AGENDA
ARCHITECTURAL COMMISSION
REGULAR MEETING
Monday, August 16, 2010 at 7:00 P.M.

ITEM # 2: For the **ARCHITECTURAL COMMISSION** on **MONDAY, August 16 @ 7:00 P.M.**

Item #2:
Report Of Architectural Commission:
C. Sunset Grove Building “B” Modifications

REQUEST: Consideration of modifications the final site plans for landscaping, signage and elevations for the Sunset Grove Planned Unit Development/Subdivision as they relate principally to Lot 1/Building "B" submitted by Mr. Kurt Wandrey Lakewood Real Estate Solutions, LLC.

EXHIBIT 2
SUNSET GROVE
LONG GROVE, ILLINOIS

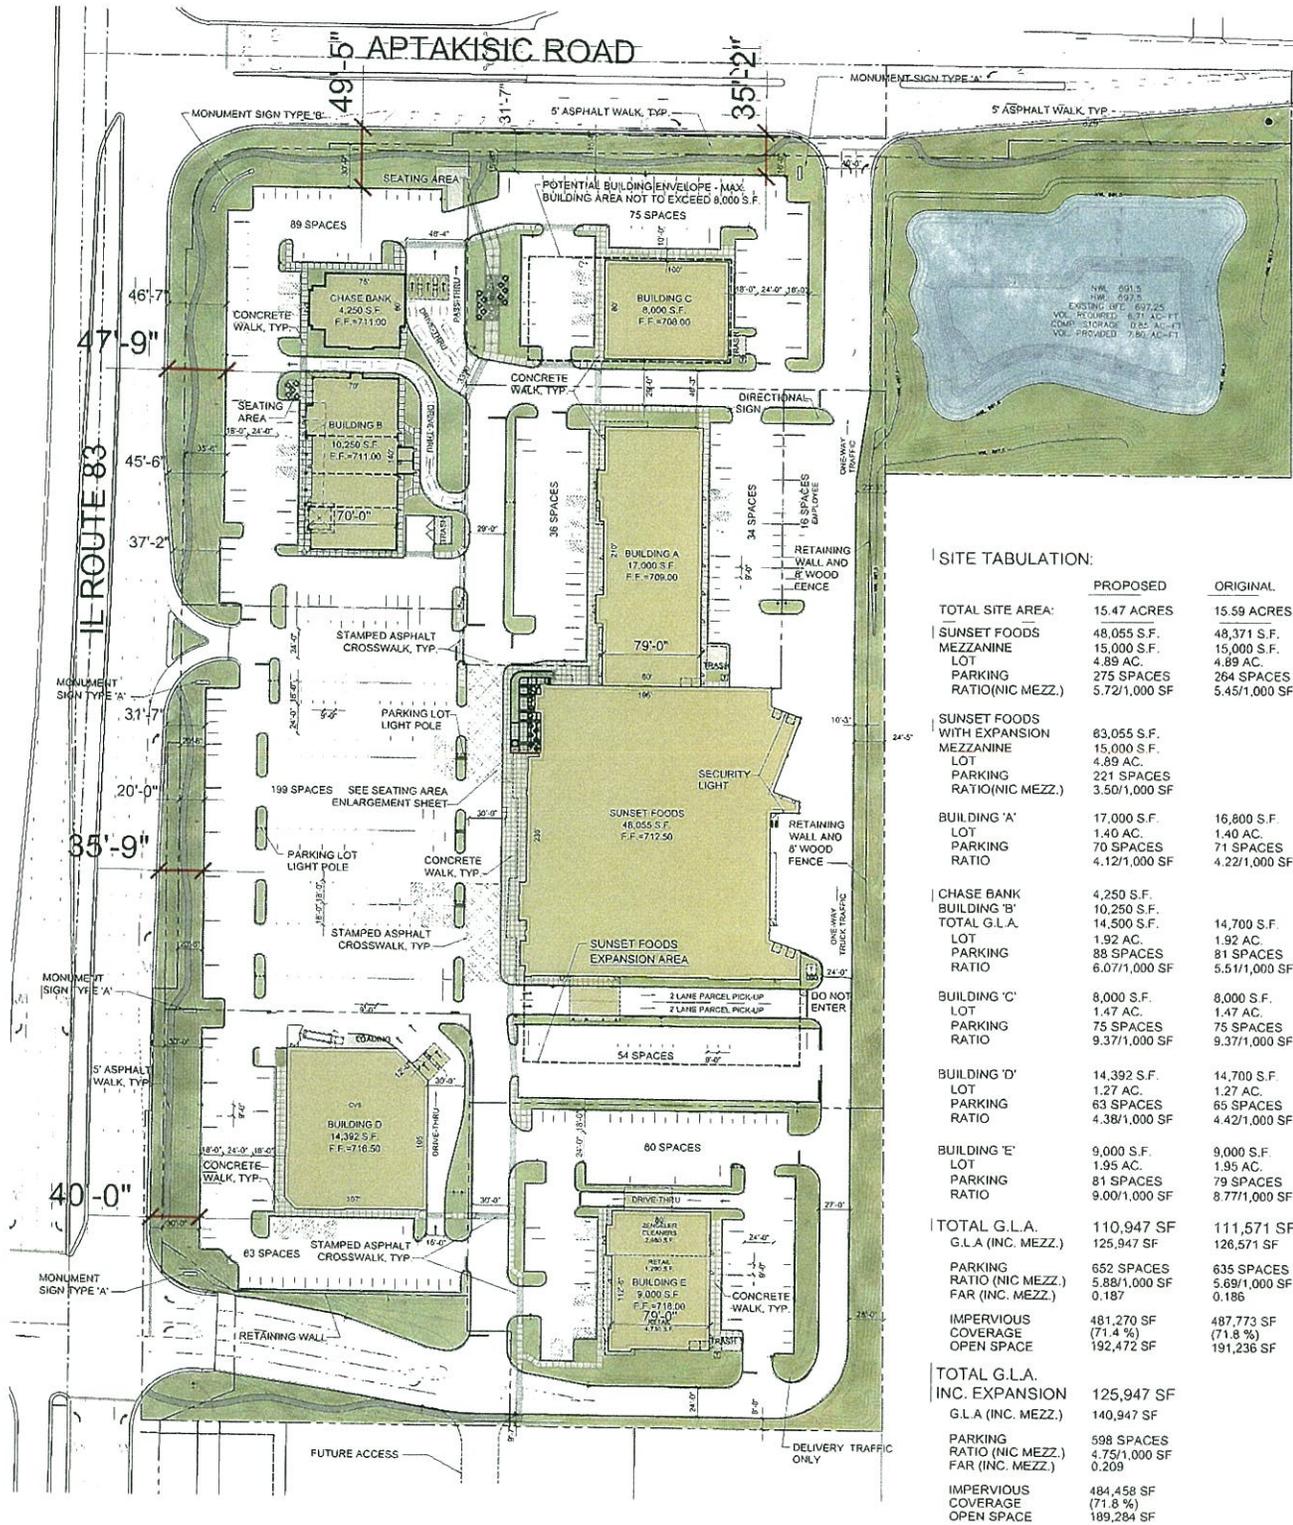
Exhibit 1 as attached is the approved site plan for the Sunset Grove Development (prepared by OKW Architects September 3, 2008). Exhibit 2 (prepared by OKW Architects July 30, 2010) is the proposed site plan which will modify the approved 2008 site plan. No modification to the previously approved PUD plat is required as no further subdivision of Lot 1 is requested at this time. Please note some of the illustrations included with this report do identify the area to be **leased** to the bank separately for purposes of clarification (Lot 1a & Lot 1b). This is simply for reference purposes, no further subdivision of Lot 1 is being considered at this time.

A new and separate bank building will be constructed on a portion of Lot 1 to be leased to Chase Bank. This is the biggest change to the site plan. Under the revised scenario parking increases, lot coverage decreases, building size decreases (slightly) and non-pervious space (i.e. green space) increases from the original approval. This is illustrated in the zoning data provided above and further illustrated in Exhibits 9 & 10. Pedestrian access to the development is enhanced as well.
